# 1975 - 1982 Corvette: Service Bulletin: Viton Accelerator Pumps - Current and Past Models Equipped with Dual and Quadrajets

**Source:** Chevrolet Dealer Service Information Bulletin

**Bulletin No:** 83-I-65

**Date:** May, 1983

FIGURE 1. (DUALJET SHOWN)

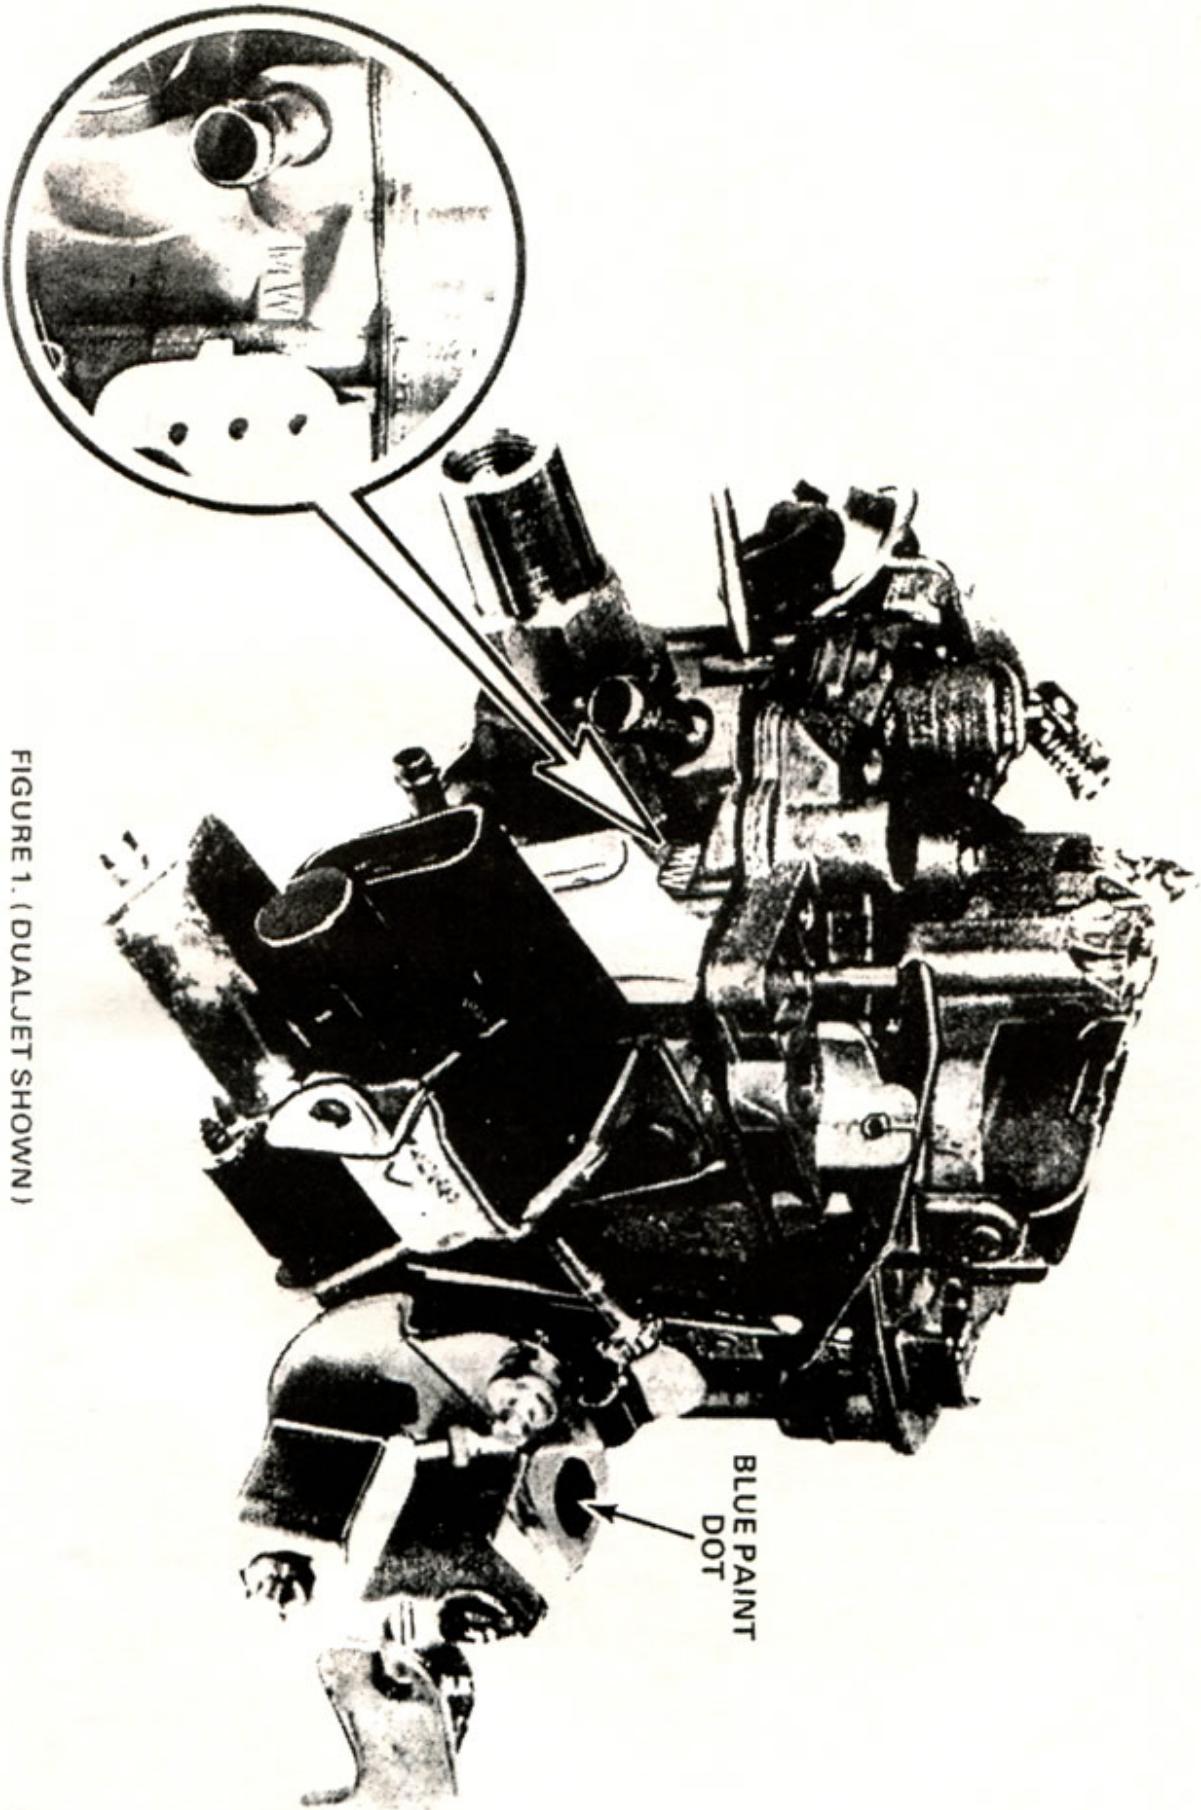
Float bowl assemblies that have the letters "MW" (machined well) embossed next to the throttle position sensor electrical connector use the red lip (with garter spring) viton accelerator pump only . See Figure 1.

Some 1982-83 "MW" flat bowl assemblies used during production were assembled with the red viton pump and some were not. if the float bowl

assembly does not contain the red viton pump, a blue dot will be on the rear of the throttle body near the bolt hole. See Figure 1.

**FIGURE 2. VITON ACCELERATOR PUMPS**

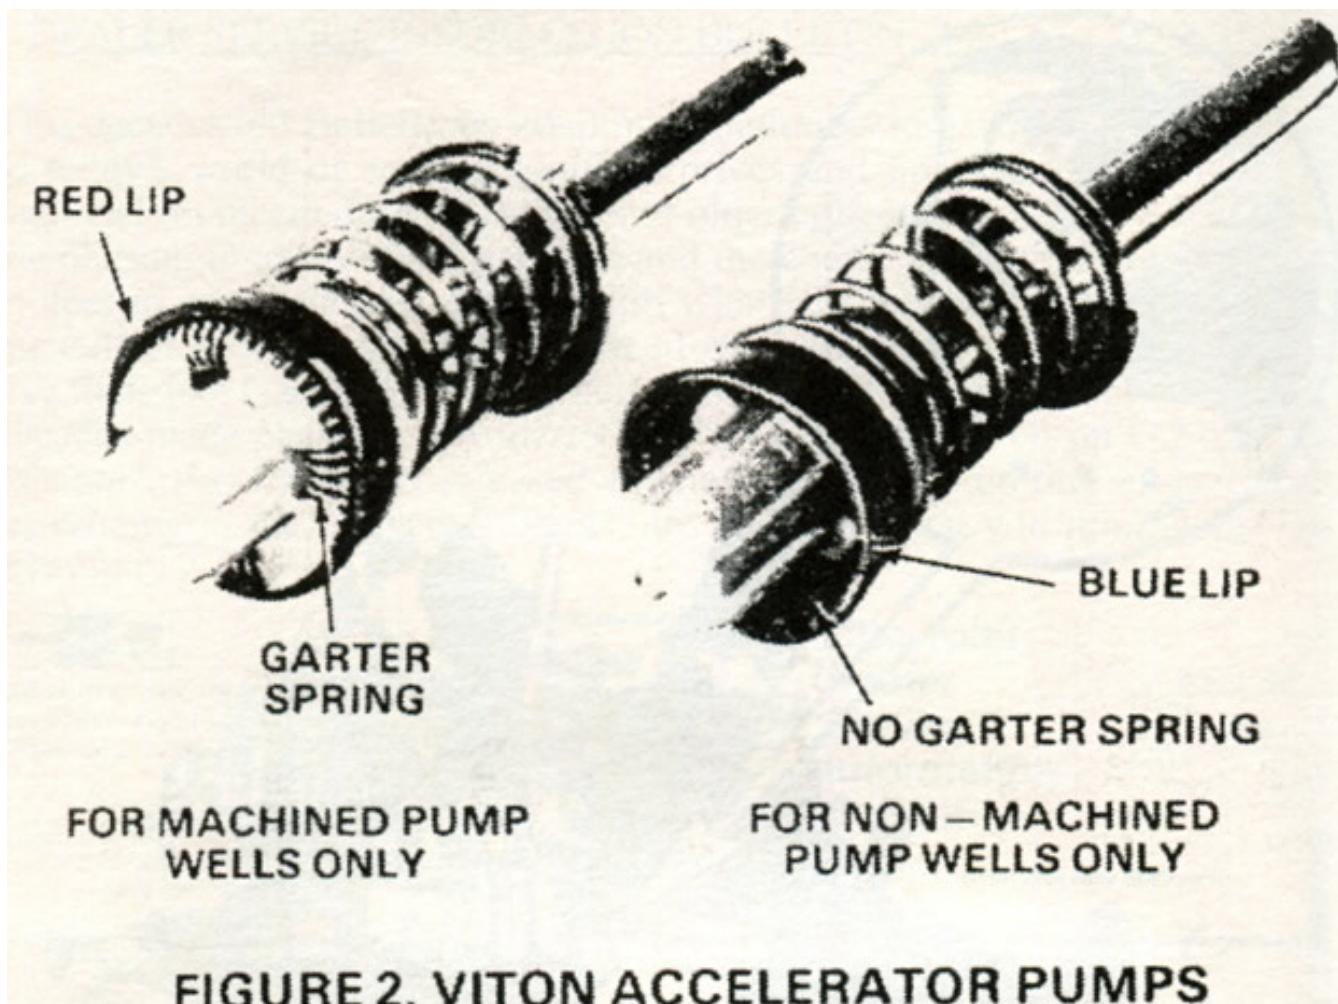
Viton service replacement pumps are identified as H.D. (Heavy Duty) in the parts book and are shown in Figure 2.

Red lip (with garter spring) -- Machined well only (MW)

Blue, thin lip -- Non-machined well only

Red lip (with garter spring) -- 17072978
